### IWG WGWT #62 extended

Questions and comments to WT-62-7v1 ETRTO Workplan proposal

JAPAN AUTOMOBILE STANDARDS INTERNATIONALIZATION CENTER

# 1. Questions and comments to WT-62-7v1 ETRTO Workplan proposal

ETRTO proposal

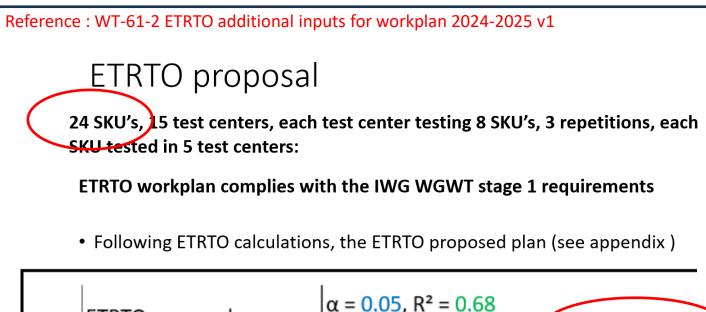
However there is no explanation about ETRTO logic (rationale, evidence) for below figures which ETRTO explained in previous IWG WGWT.

Please show us at first.
